Relevant Information for Local Planning Panel

FILE: D/2019/1163 **DATE:** 25 November 2020

SUBJECT: Information Relevant To Item 3 – Development Application: 51 Buckingham Street, Surry Hills – D/2019/1163

Figure 1: View from living room at 72/156 Chalmers Street, Surry Hills, looking north-west

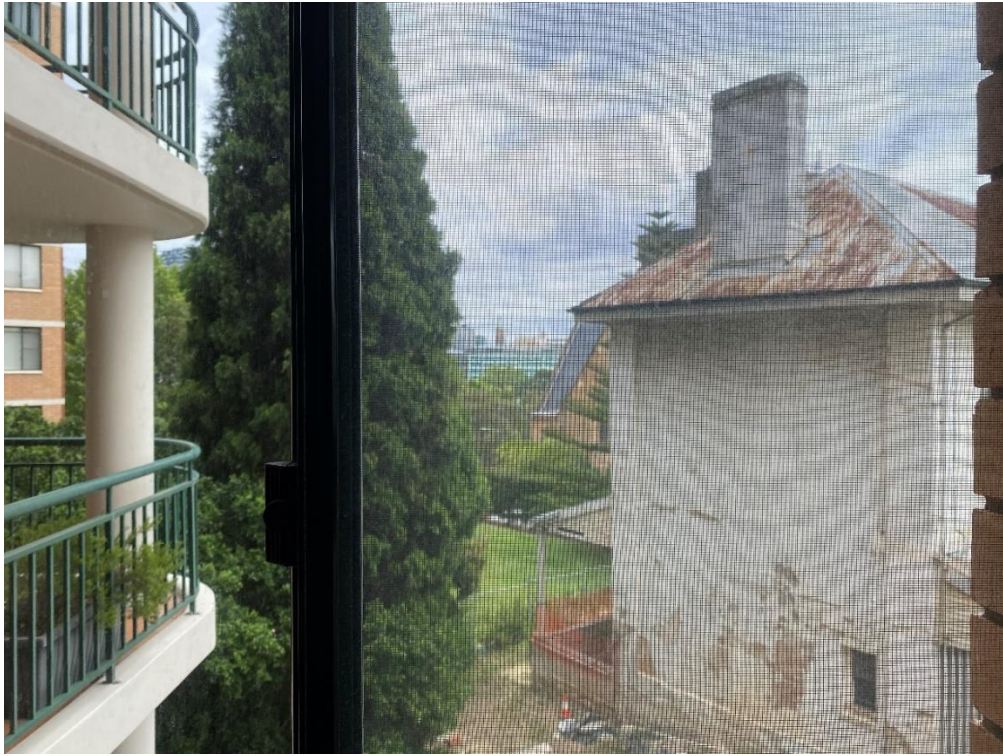
Notwithstanding, a site inspection of the objector's apartment was undertaken by Council officers on 24 November 2020. The below photos were taken:

The submission raised concern about views obtained from a balcony and living room. During the site inspection it was observed that views are also obtained from a north-facing bedroom.

It is noted that the impact on views from living areas is more significant from bedrooms or service areas.
